**TOWN OF GLASTONBURY**  
GL-2021-04  
**BROADCAST VIDEO SYSTEM REPLACEMENT**  
ADDENDUM NO. 3  
February 12, 2021

Bid Due Date: 02-23-2021 @ 11:00 A.M.

**AV-501**

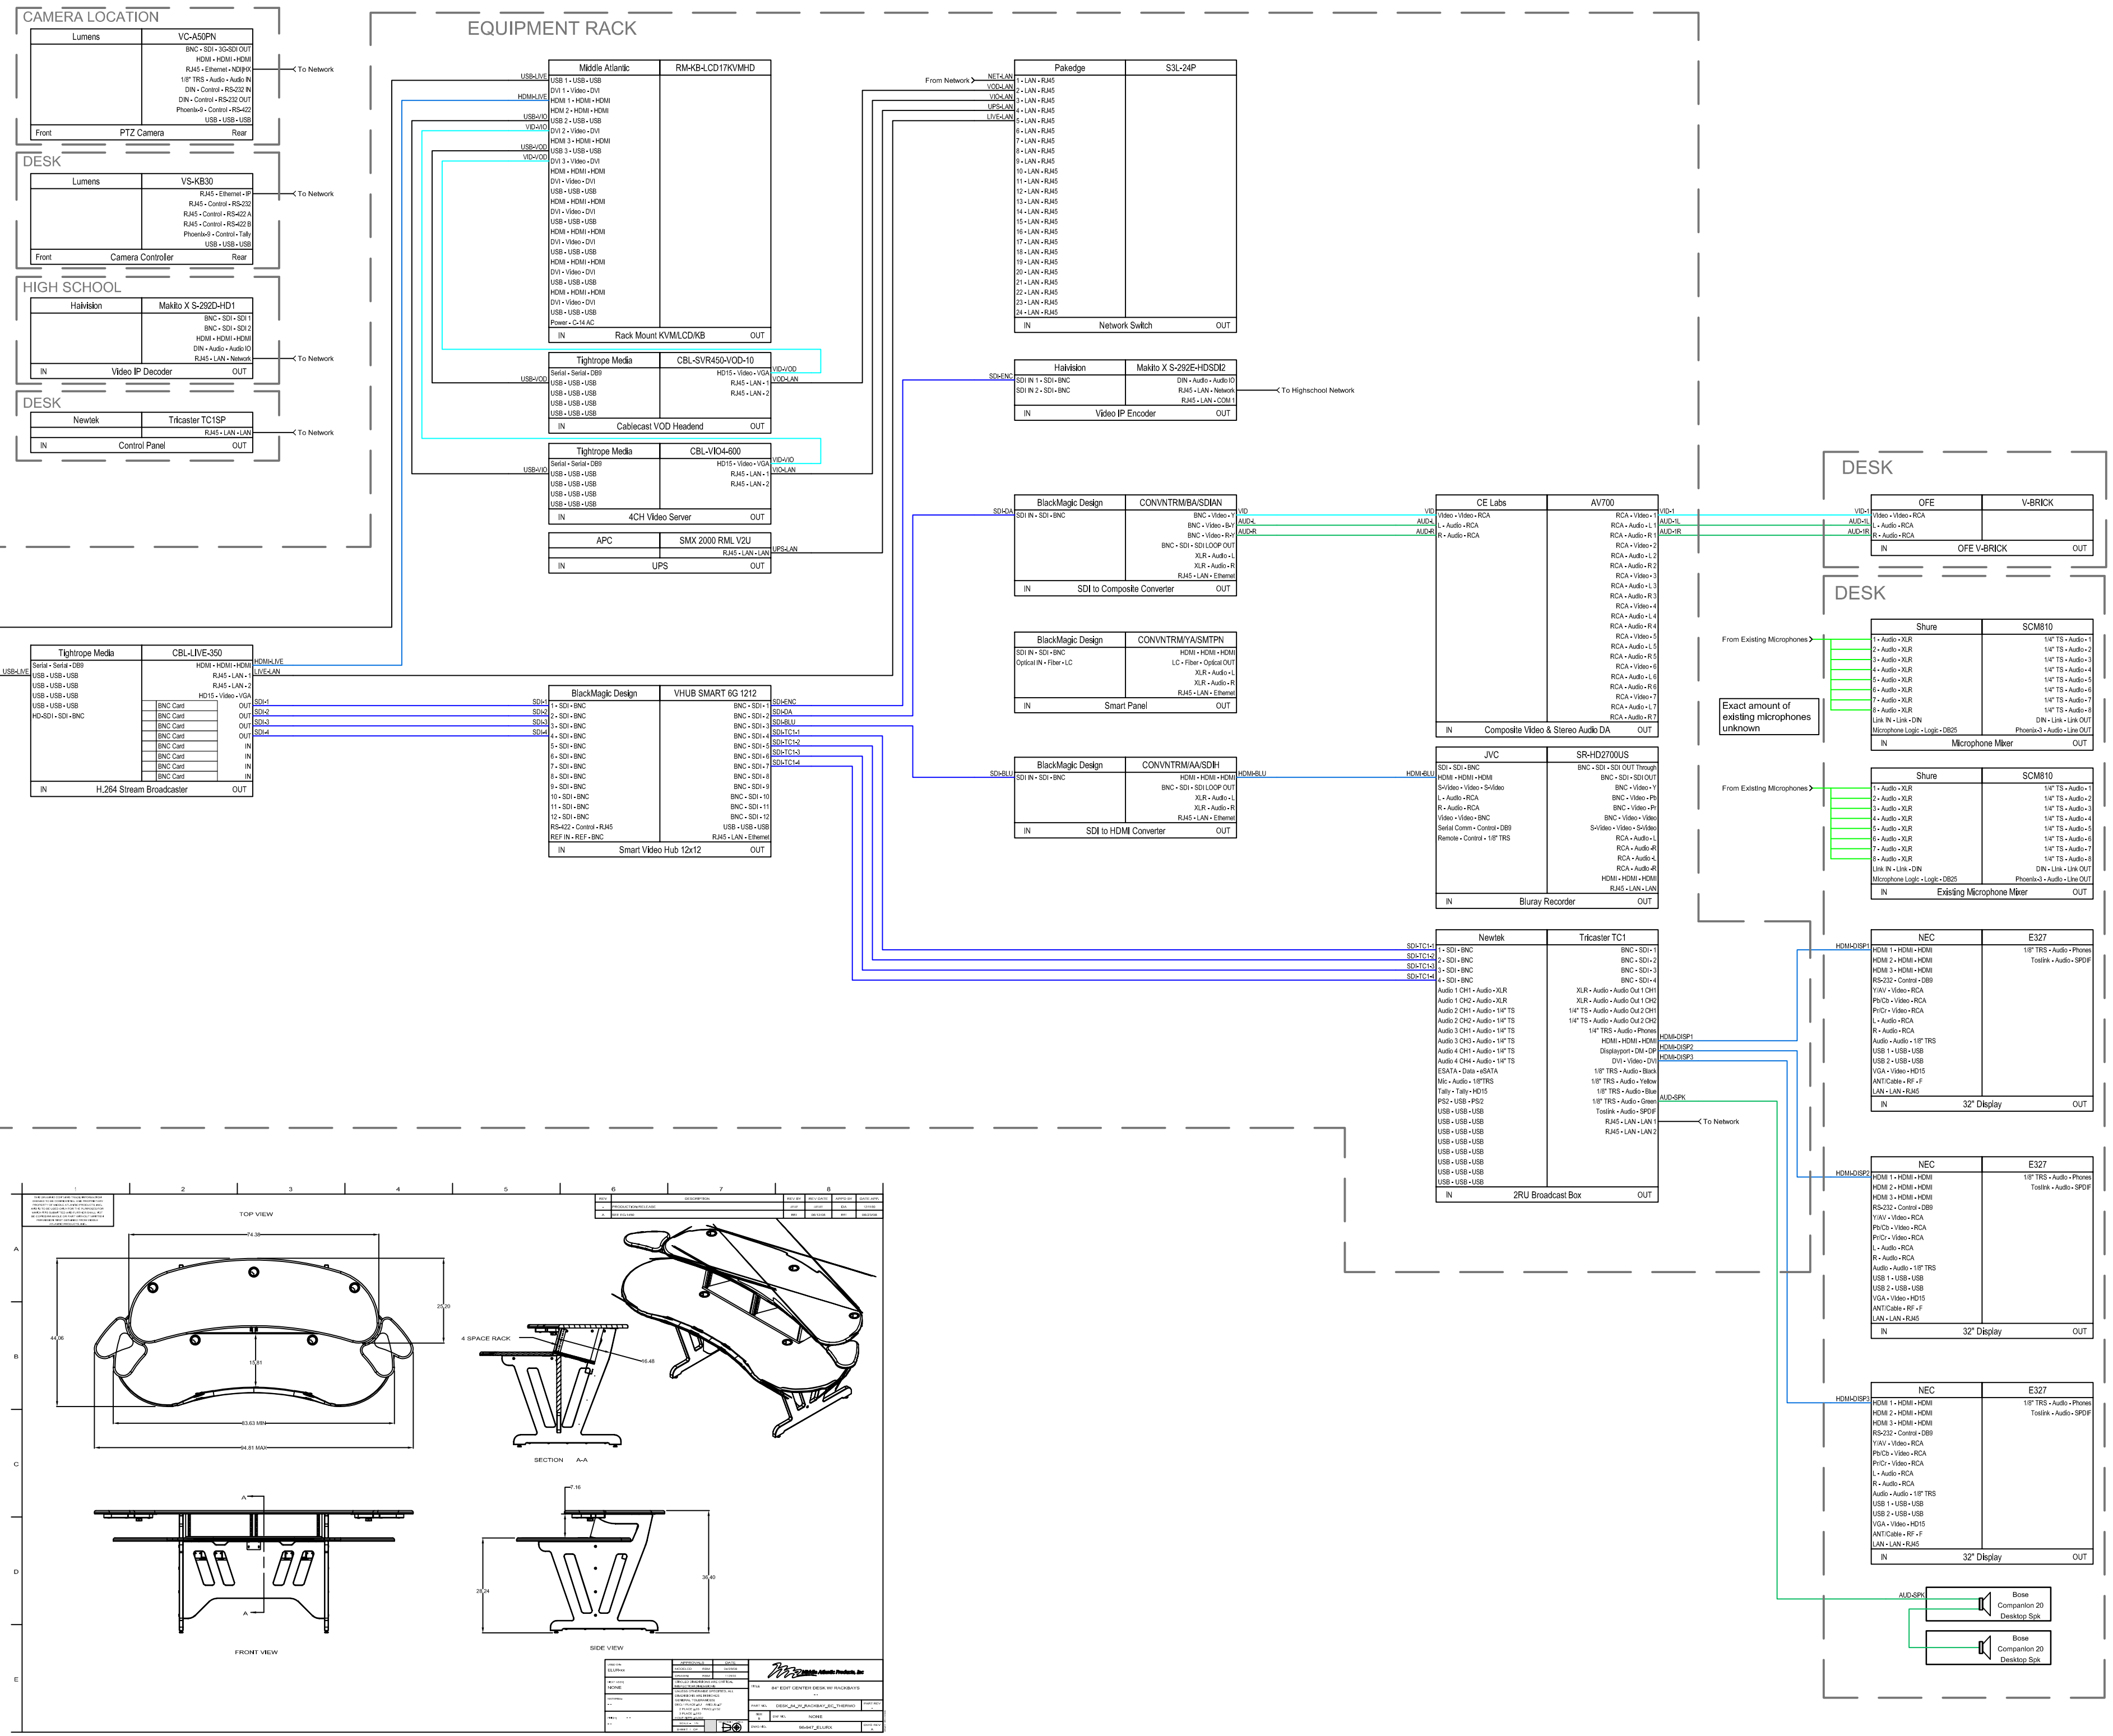
**Question 6:** *My estimating team could not read "ATTACHMENT D - System Flow and Console Layout drawing". Is there a way to get a more legible document?*

**Answer:** See Pdf of line drawing posted as part of Addendum No. 3.
